**Environmental
Planning
Commission**

**Agenda Number: 08
Project Number: 1000202
Case Number: 17EPC- 40057
Hearing Date: December 14, 2017**

Staff Report

Agent	Treveston Elliot Architect
Applicant	Alamo Center, LLC
Request	Site Development Plan for Building Permit
Legal Description	Alameda West Shopping Center Tracts A-D, E-1, E-2, Gas Company of NM and Gas Company of NM Easement
Location	Seven Bar Loop Rd. NW, between Coors Blvd. NW and Cottonwood Dr. NW,
Size	approximately 22.5 acres
Existing Zoning	SU-1 for C-2 uses
Proposed Zoning	No change

1 Site Plan - Proposed
Scale 1" = 50' N

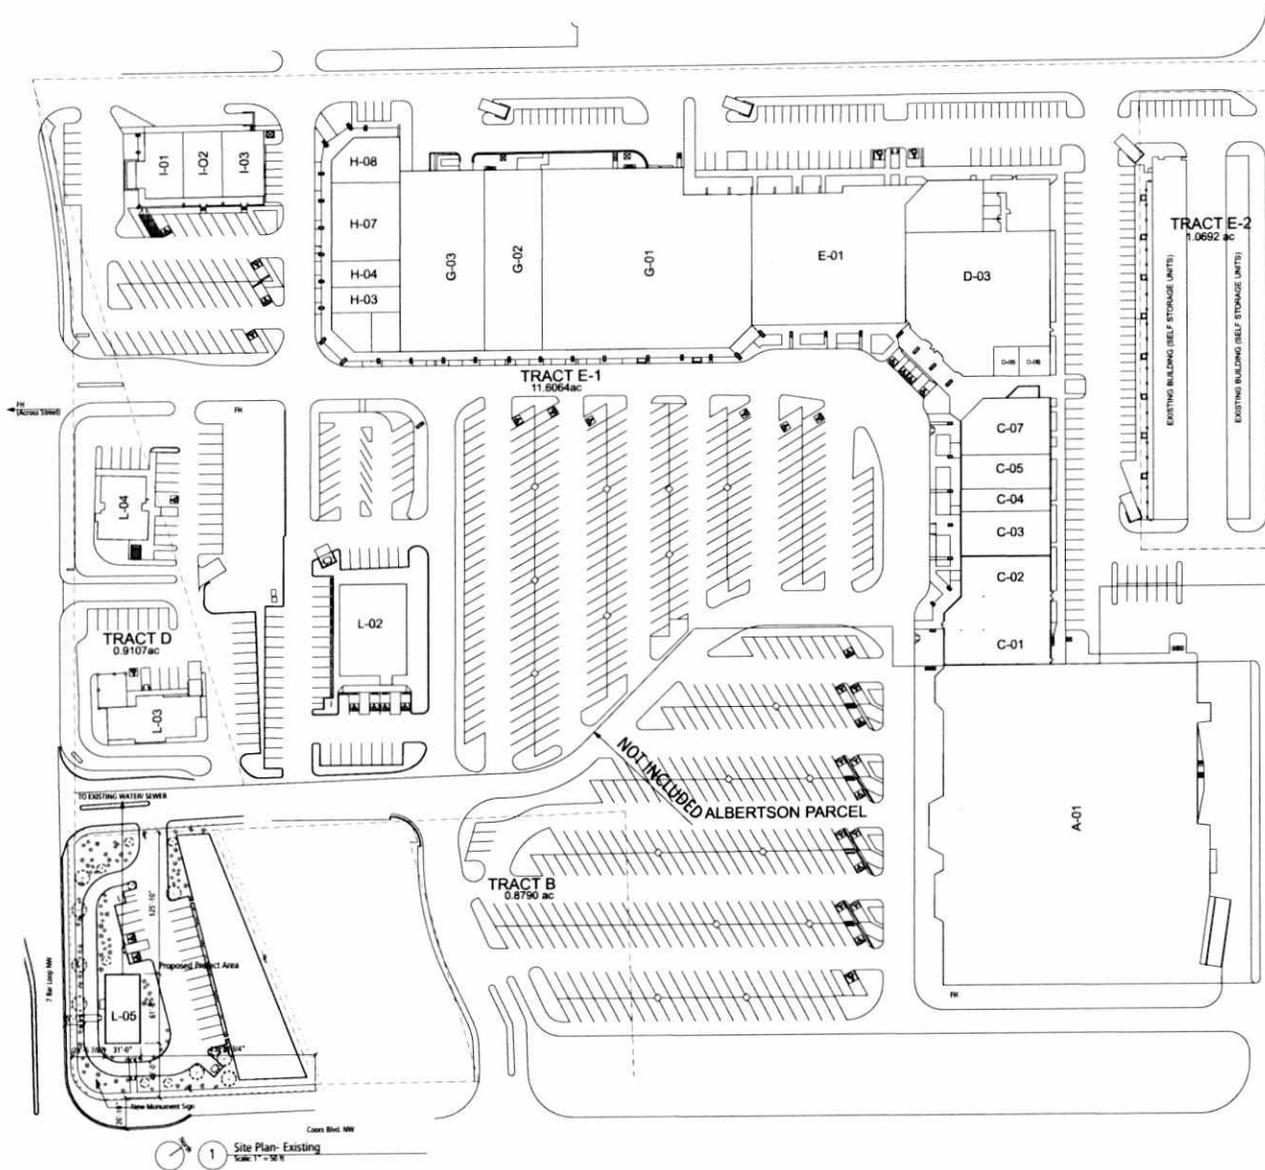
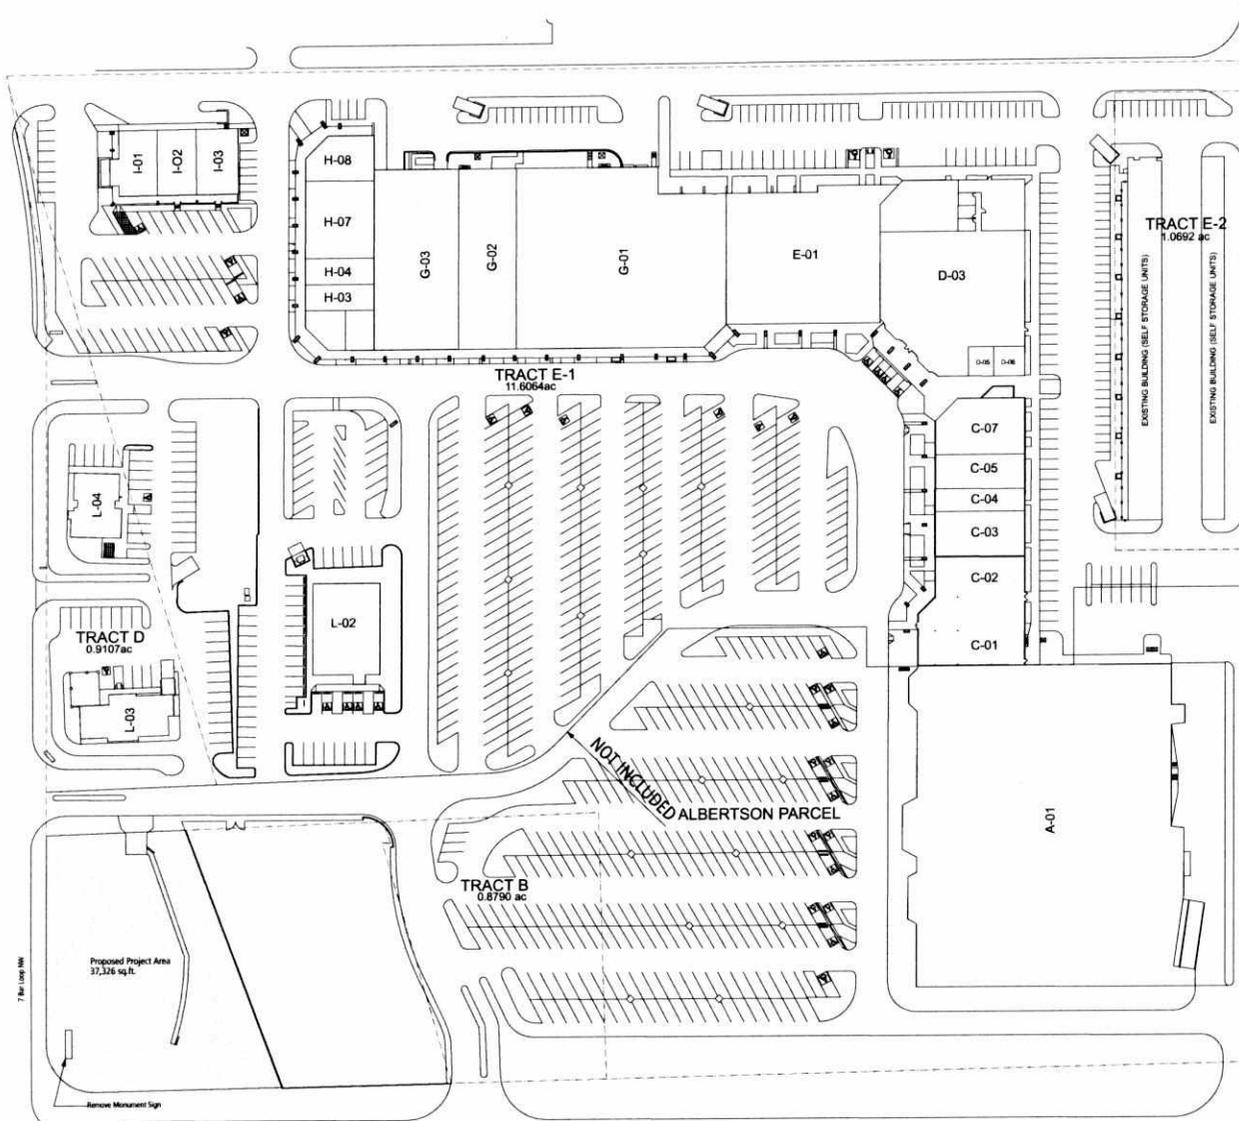
The landscape plan shows a 15 foot wide landscape strip on the subject sit, however there is an additional 25 feet of landscaped area between Coors Boulevard and the site . This configuration meets the intent of the 35 foot landscape buffer.

The site plan shows an approximately 600 square foot patio space at the front entrance with a 400 square foot landscaped area to the east of the patio..

The applicant proposes a bike rack west of the building at the beginning of the sidewalk connecting to the building. This location is visible from the patio and protected from traffic. The applicant will be required to provide a sidewalk along Coors Boulevard and along Seven Bar Loop; pedestrian connections will be provided from the building to the sidewalks on both streets.

The layout of the building and the drive-up service window queuing lane do not provide any pedestrian access from Coors Boulevard or Seven Bar Loop to the entrance of the building. There are no pedestrian connections to the rest of the shopping center.

Need complete/detailed site plan to scale, w/all entrances/exits clearly indicated w/dimensions and all surrounding PROW's. Will need to either relocate new/proposed refuse enclosure location, provide a turn around area for refuse truck, or provide an alternate exit for safe refuse truck access/exit. All new/proposed refuse enclosures must be built to COA minimum requirements.

Regarding comments from Long Range Planning, the applicant added pedestrian connections to Coors Boulevard and Seven Bar Loop and a connection across the entry drive to the adjacent restaurant.

GRADING AND DRAINAGE PLAN

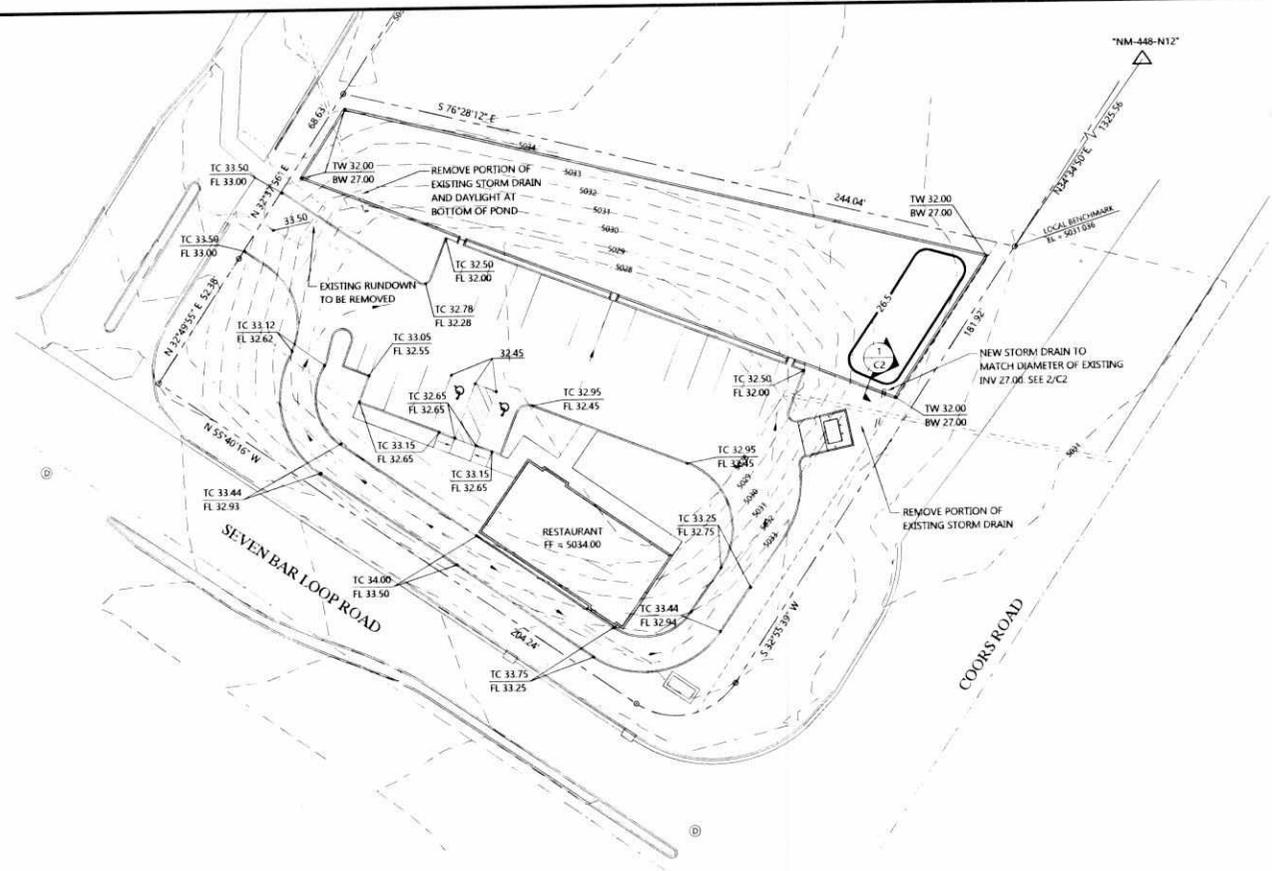
AMAFCA had questions about the reengineering of the site, the applicant has met with hydrology regarding the site and the new drainage plan. The plan is acceptable to the hydrology division.

A Grading and Drainage Plan & Report must be approved by Hydrology prior to approval of the Site Plan for Building Permit by the DRB.
